HW Declaration

GX0301 HW v2.0 to v2.1

This document describes the HW changes from the product GX0301 (Etna GT NAR – HW version 2.0) to the GX0301 (Etna GT NAR – HW version 2.1).

2. Physical difference

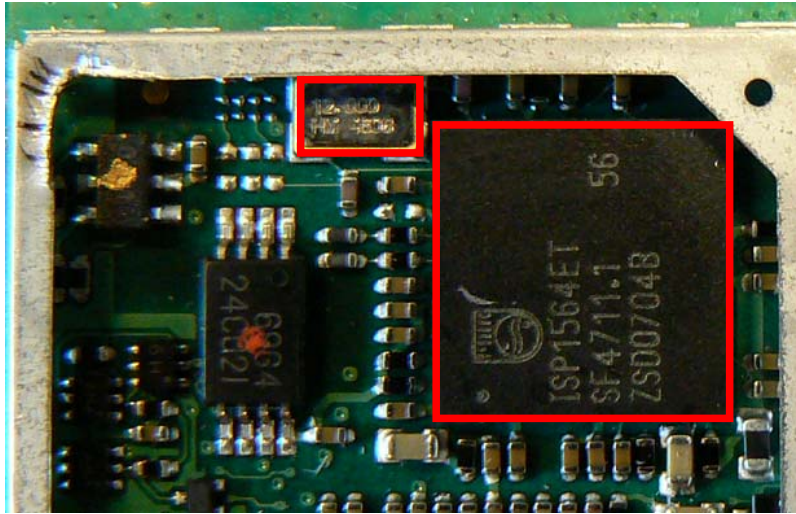
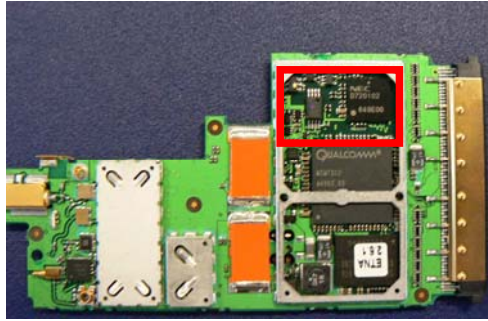
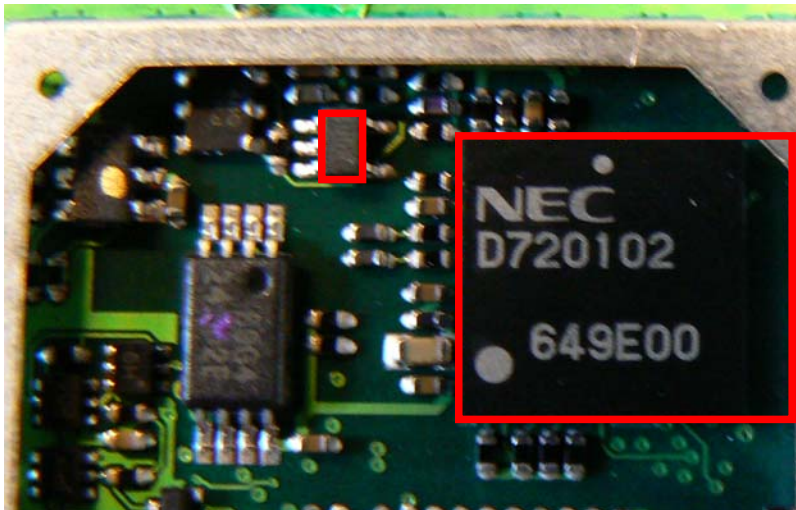
Components needed for the USB host controller (eg: crystal oscillator) needed to be changed in order to have maximum efficiency of the USB host controllers. Changes are described in following paragraphs.

Figure 3: GX0301 HW v2.0 PCB layout top

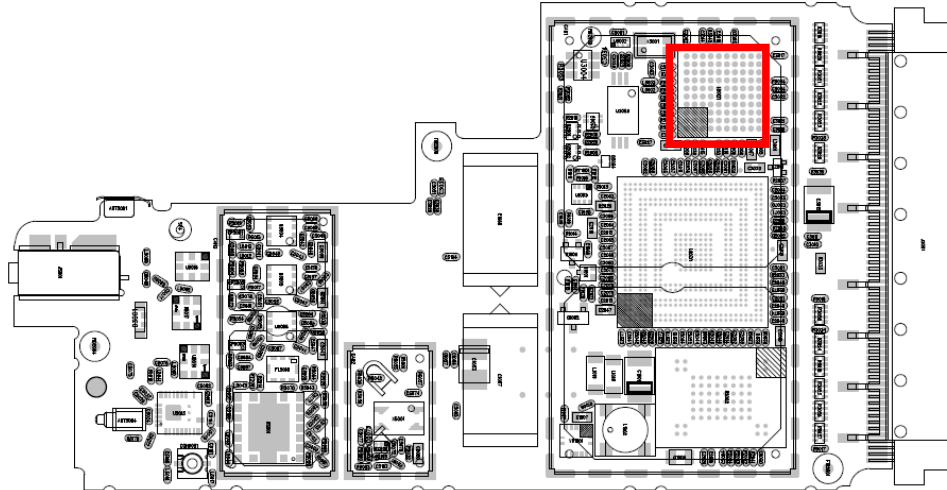
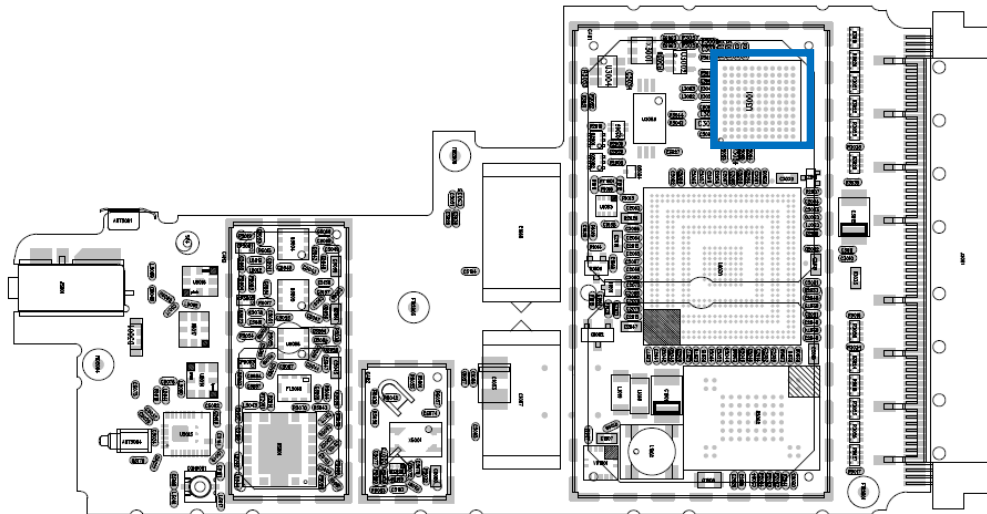
Both USB host controllers are indicated in the PCB layout.

This change has no effect on the performance of the card. The changed component is only used for conversion of the cardbus protocol (used by the notebook) into a USB bus (used by the datacard). Because of no baseband and no RF change we would only like to do some protocol spotchecks where communication between the notebook and the datacard is needed.
